Docket Number:	21-BSTD-02
Project Title:	2022 Energy Code Update CEQA Documentation
TN #:	238719
Document Title:	NRDC Comments on Draft Environmental Impact Report for 2022 Building Standards
Description:	N/A
Filer:	System
Organization:	NRDC
Submitter Role:	Public
Submission Date:	7/7/2021 3:31:16 PM
Docketed Date:	7/7/2021

**NRDC Comments on Draft Environmental Impact Report for 2022
Building Standards**

Re. NRDC Comments on NRDC Comments on Draft Environmental Impact Report for 2022 Building Standards Released May 19, 2021, Docket Number 21-BSTD-02

Figure 1: Lifetime Emissions Reductions from Installing a Heat Pump vs. a Gas Furnace With 20-Year Global Warming Potential

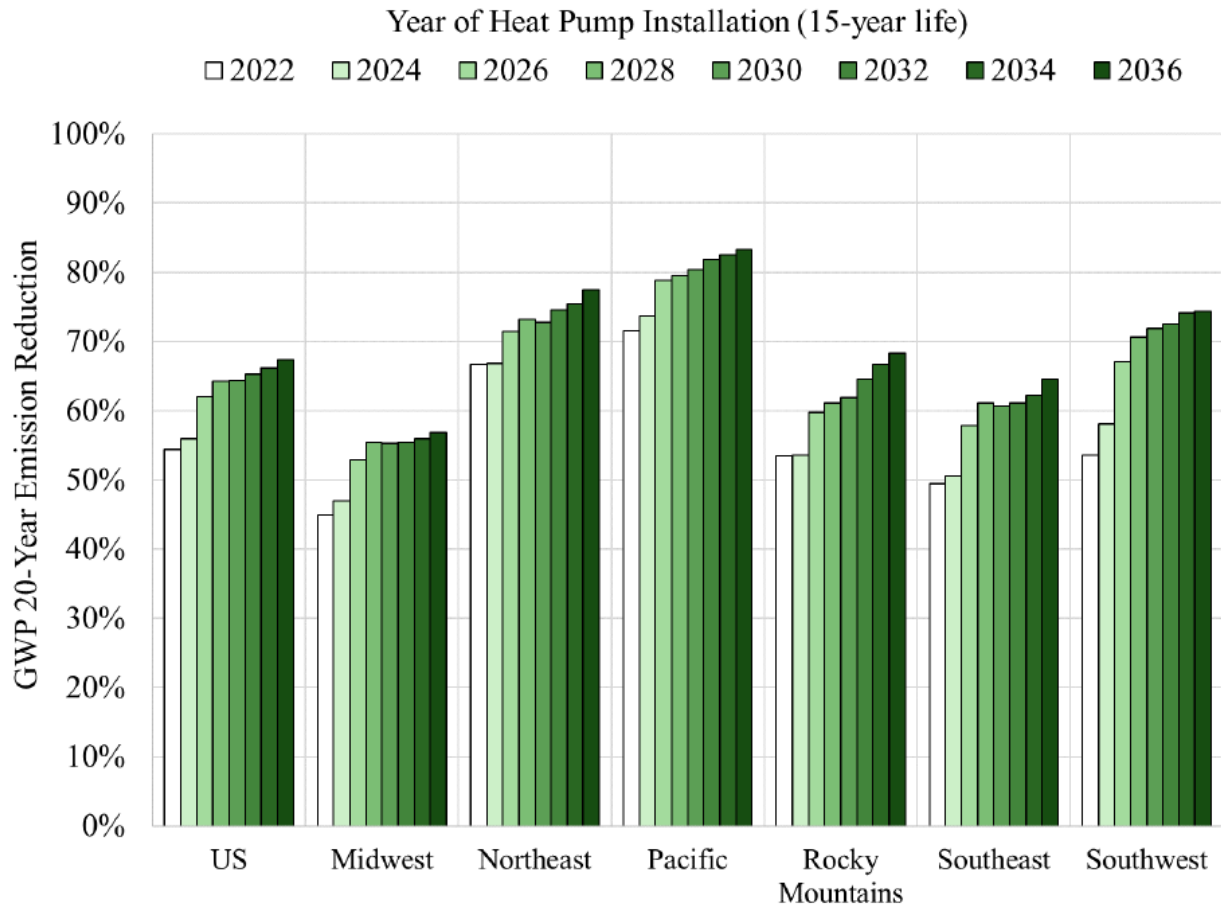
NRDC supports the findings of the Draft Environmental Impact Report that the 2022 building energy code (the "2022 Code") would result in a reduction of GHG emissions statewide. In fact, CEC's analysis is overly conservative for several reasons, and NRDC estimates that the 2022 Code would result in a much larger reduction of GHG emissions statewide.

The biggest reason is that CEC's analysis does not include the indirect benefits of all-electric new construction: as space and water heating in new construction transitions from fossil fuels to highly-efficient electric heat pump technologies, the price of these technologies will fall as it did with solar energy technologies over the past 15 years, and familiarity and capacity among installers will increase, leading to much lower equipment and installation costs. This will accelerate electrification of space and water heating in existing buildings, which are responsible for the bulk of energy related GHG emissions in buildings. Therefore, **the 2022 Code will indirectly contribute to energy related GHG emissions reductions in California's building sector in excess of 70 percent for heat pumps installed in the 2023-2025 time period, and more than 80 percent by 2030.**

- Figure 1 shows emissions impacts for the entire U.S. Pacific region, which includes the states of California, Oregon, and Washington. NREL emissions factors are slightly lower for California than for other Pacific states, so California-specific results would show higher emissions reductions than for the entire Pacific region.

- WCEC's study includes out-of-state methane emissions associated with gas imported into California for use in buildings, whereas CEC's includes in-state leakage only. California imports 90 percent of the gas used in the state, and the majority of methane emissions takes place at the extraction well. Phasing out gas use in California's buildings will result in fewer new gas wells drilled, and therefore a reduction in associated methane emissions. California Air Resources Board accounts for out-of-state emissions for electricity generation, the same approach should be used with fugitive methane emissions for consistency and to allow for a fair comparison of the GHG impacts of fossil fuels vs. electric alternatives.

However, the WCEC study shows that both methane and refrigerant emissions are significantly lower than the direct CO₂ emissions of gas furnaces and heat pumps, so they do not directionally change the results of the study. The WCEC study therefore corroborates CEC's analysis findings that electrification of space heating significantly reduces emissions compared to gas furnaces.
